**PROCEEDINGS OF THE MEETING OF STATE LEVEL EXPERT APPRAISAL
COMMITTEE, ODISHA HELD ON 20TH SEPTEMBER 2024**

PROPOSAL FOR ENVIRONMENTAL CLEARANCE OF M/S TRIMETRO GARMENTS INDIA PVT. LTD FOR INDUSTRIAL SHED OF EPIC APPAREL MANUFACTURING INDUSTRY WITH TOTAL BUILT- UP AREA: 81902 SQM OVER PLOT AREA- 1,59,972.2 SQ.MT. / 39.53 AC./ 15.99 HA. AT VILLAGE - KALIBATI, DISTRICT - KHORDHA, STATE – ODISHA OF SMT. ANU ARORA - EC

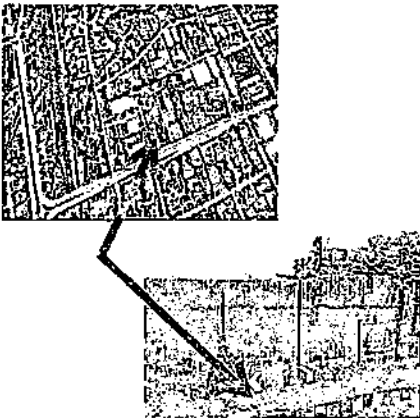
Sl. No.	Information Sought by SEAC	Compliance furnished by the proponent	Views of SEAC
8.	Permission for storm water and excess treated sewage water discharge to IDCO drain.	<p>1. The proponent has the necessary maintenance charges to maintenance of all amenities like roads, public health works, drainage, sewerage disposal system etc. in respect of the property in the industrial estate, as decided by IDCO from time to time.</p> <p>The lessee (Sparsh Optimum Healthcare Pvt. Ltd.) already paid all charges for consumption of electricity, water etc./ground water etc. directly to the concerned authorities (IDCO).</p> <p>1. Agreement with IDCO is attached as Annexure-C-(1)</p> <p>DRAINAGE NETWORK</p> 	Submitted.
